PARTS & SERVICE NEWS

REF NO.	AT03108A
DATE	Oct. 22, 2003
(C) Page 1 of 3

SUBJECT: REPAIR PROCEDURE OF COOLANT LEAKAGE OF RADIATOR

APPLICATION: WA200-3 Wheel Loaders, Serial Nos. ~~60001~~ thru 64393  63001
 WA250-3 Wheel Loaders, Serial Nos. 65001 thru 66553
 WA250-3A Wheel Loaders, Serial Nos. 53001 thru 54117
 WA250PT-3 Wheel Loaders, Serial Nos. ~~51001~~ thru 51012  50001

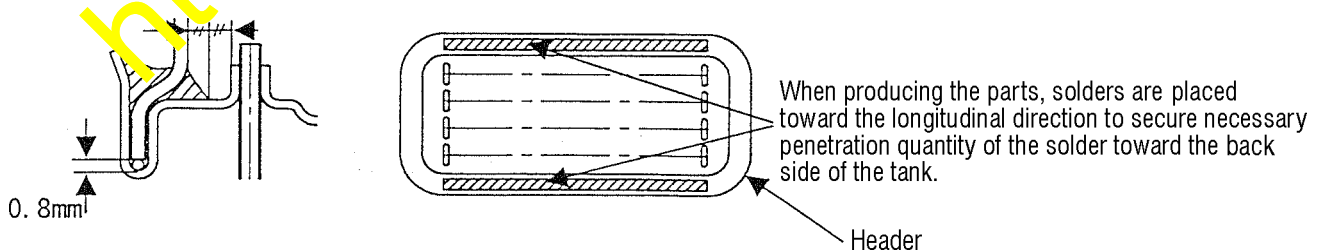
- 1) The soldering which is fastening the tubes at the four corners of the radiator core and the header may be cracked and separation of these parts may occur to result in water leakage.

- 1) The patch plate has been added to the header at the four corners of the radiator core for the reinforcement purpose.

- 2) To prevent occurrence of variation of the solder penetration in the engaging portion of the header and the tank, solder penetration shape and the penetration quantity have been specified.

4.1 Replacement of the parts

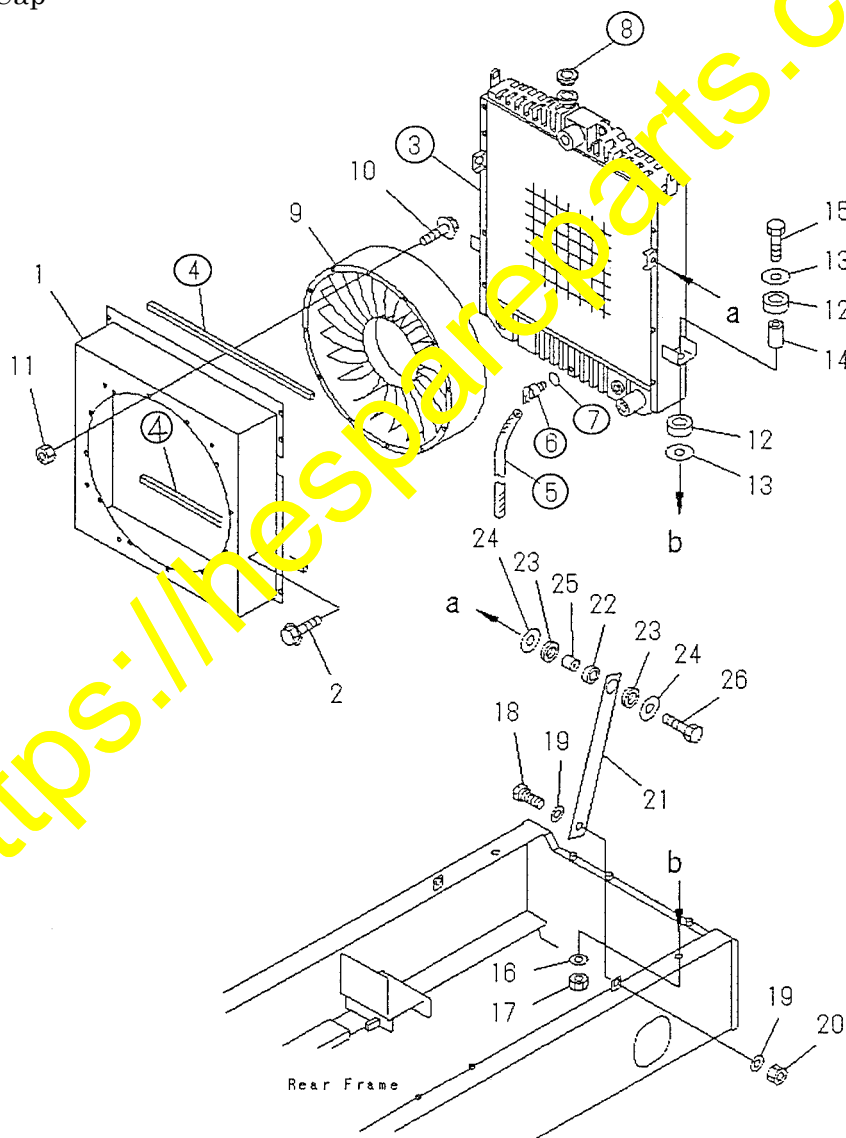
Replace the radiator ass'y referring to the Section "Disassembly and Assembly" in the Shop Manual.

Remove the parts ③, ④, ⑤, ⑥, ⑦ and ⑧ shown in the drawing below and replace them with the prepared new parts for this modification.

Radiator ass'y newly prepared for this modification (418-03-24100)

- The following parts will be sent to you from our factory in sub-assembled state.

3. Radiator core
4. Packing
5. Hose
6. Drain cock
7. O-ring
8. Cap
